FERMI NATIONAL ACCELERATOR LABORATORY
 UNITED STATES DEPARTMENT OF ENERGY
ME SON TEV II TARGET TRAIN ASSY
 EXPERIMENTAL AREAS DEPT
 SCALE: 1-1/8" FILMED DRAWING NUMBER: 121A-ME-174072 REV. A
 SHEET 2 OF 2

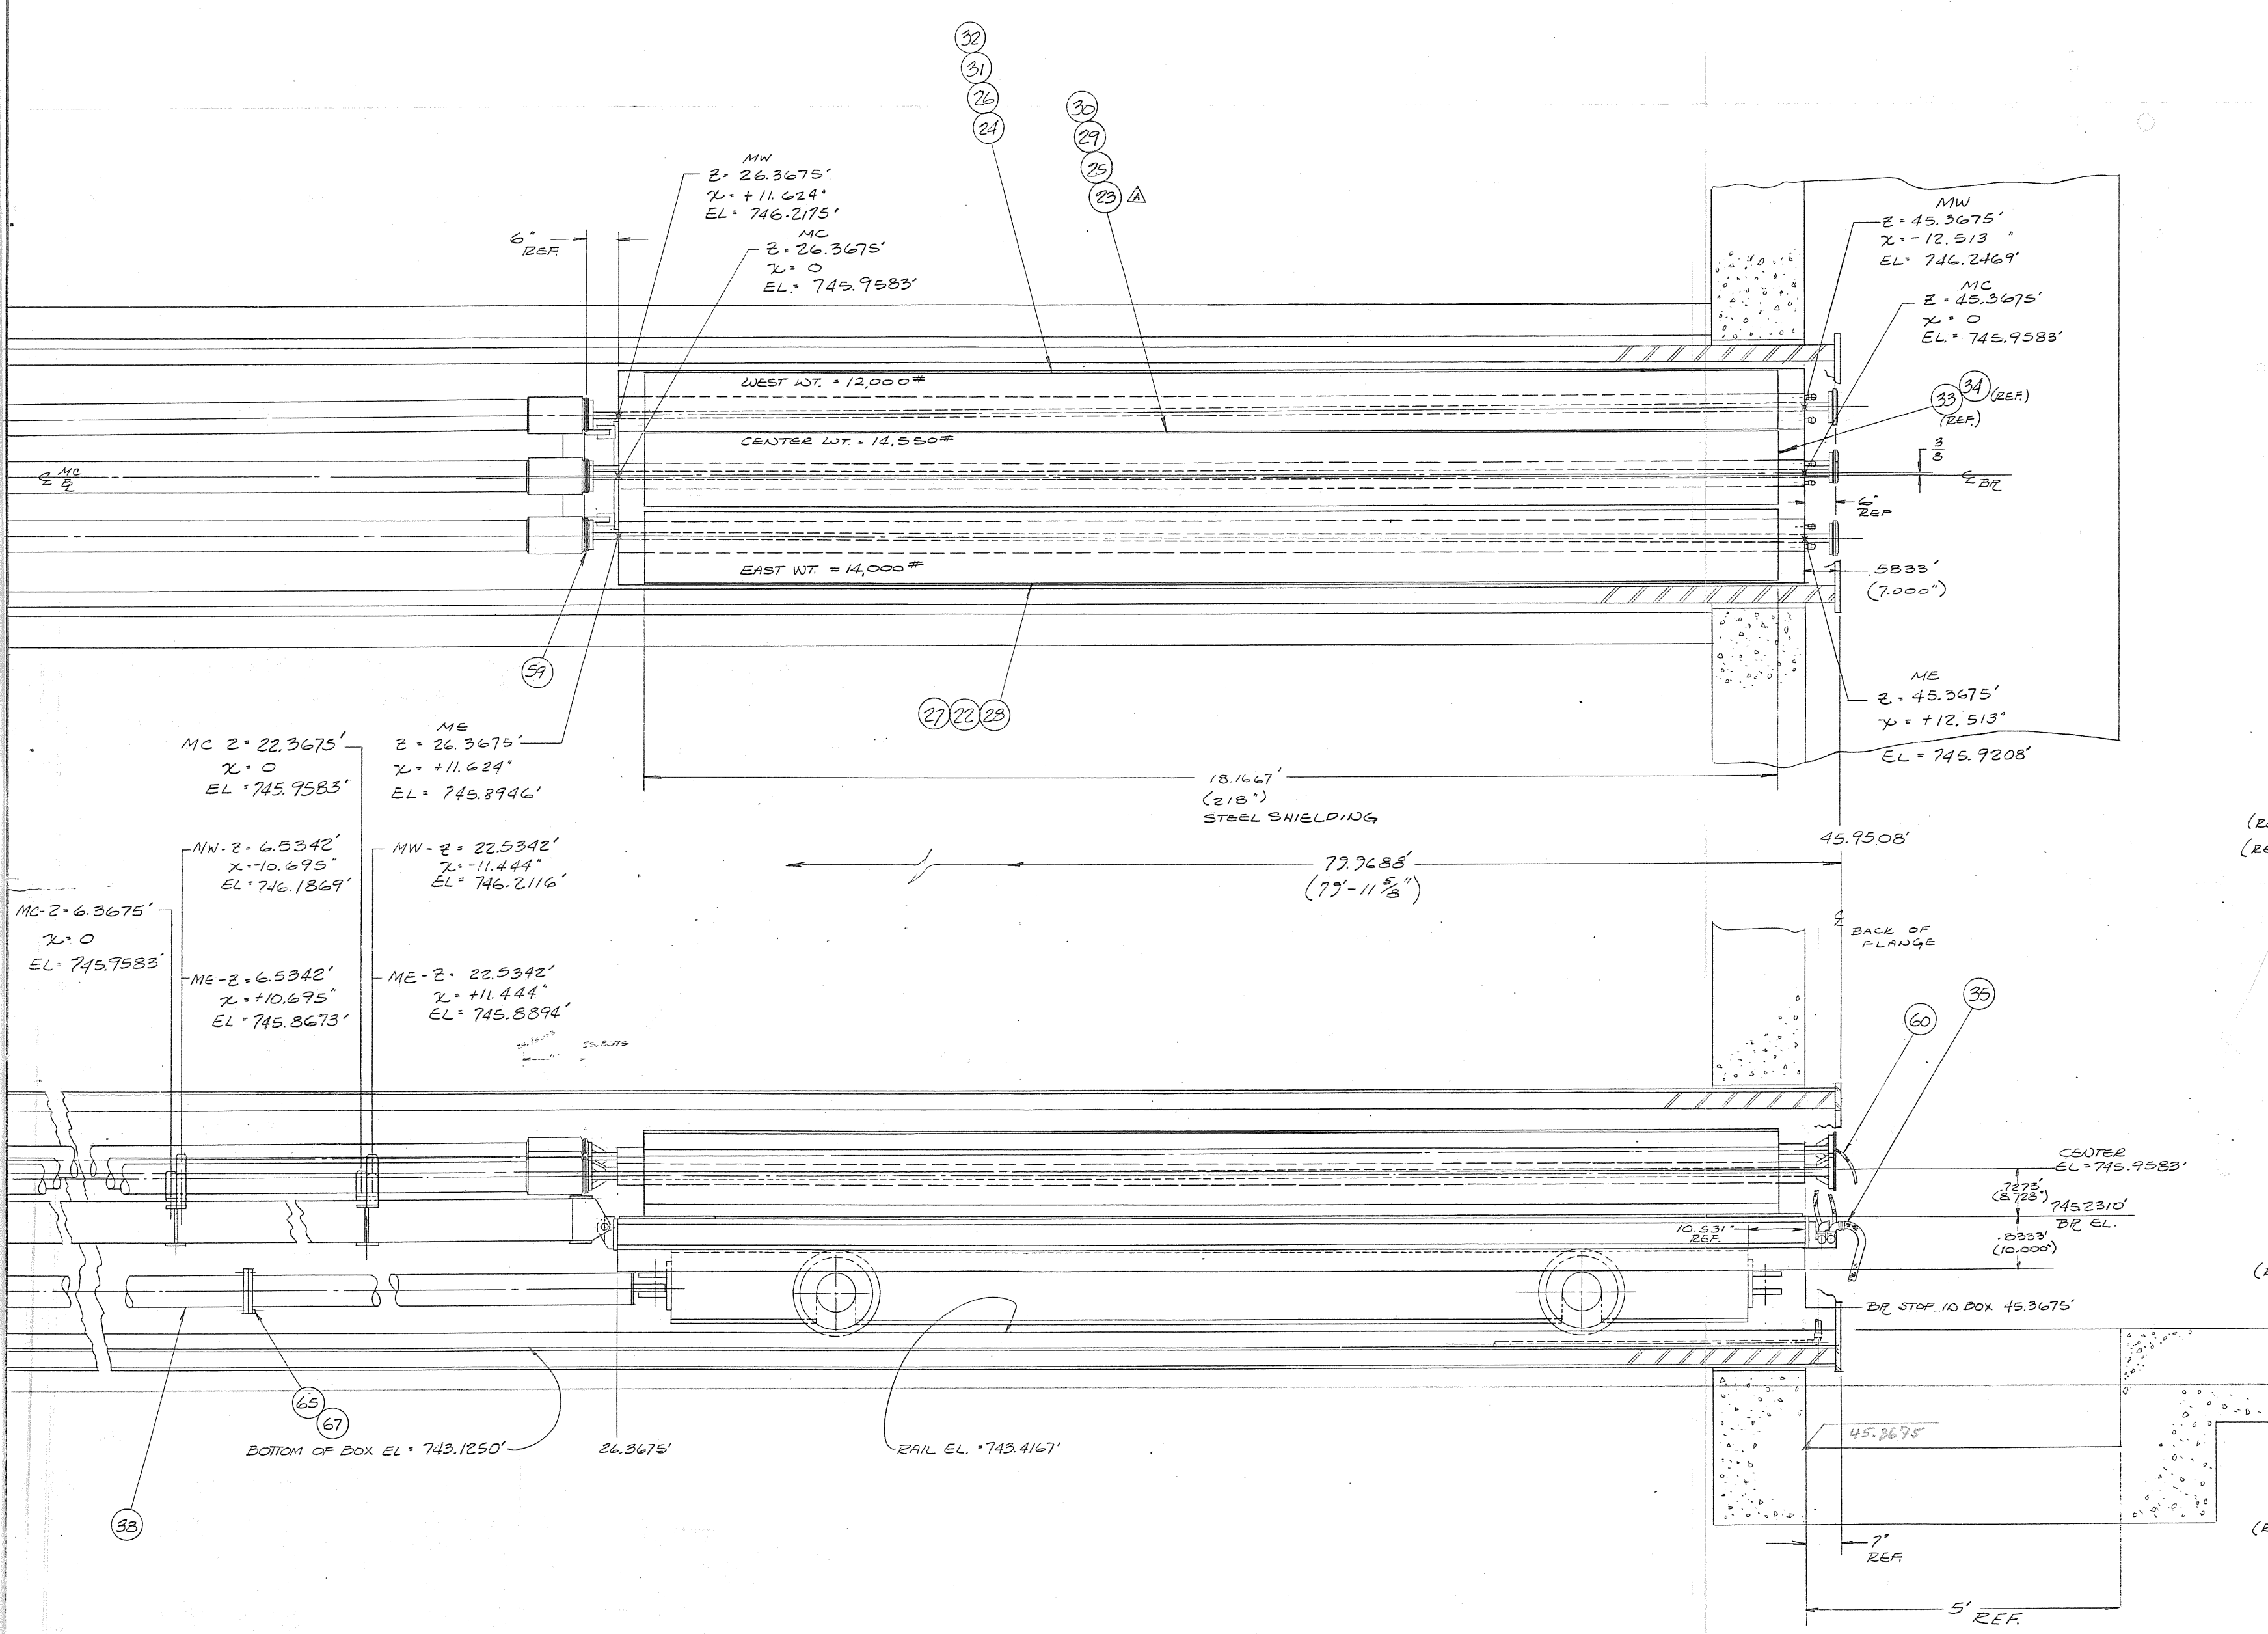
REV.	DESCRIPTION	DRAWN	DATE
A	REPLACED OLD CTR. COL. ASSY #MD-174082 WITH NEW CTR. COL. ASSY #MD-174072 1/4" 1/2" TARGET ORIENTATION BY 90°	VLJ	7-5-82
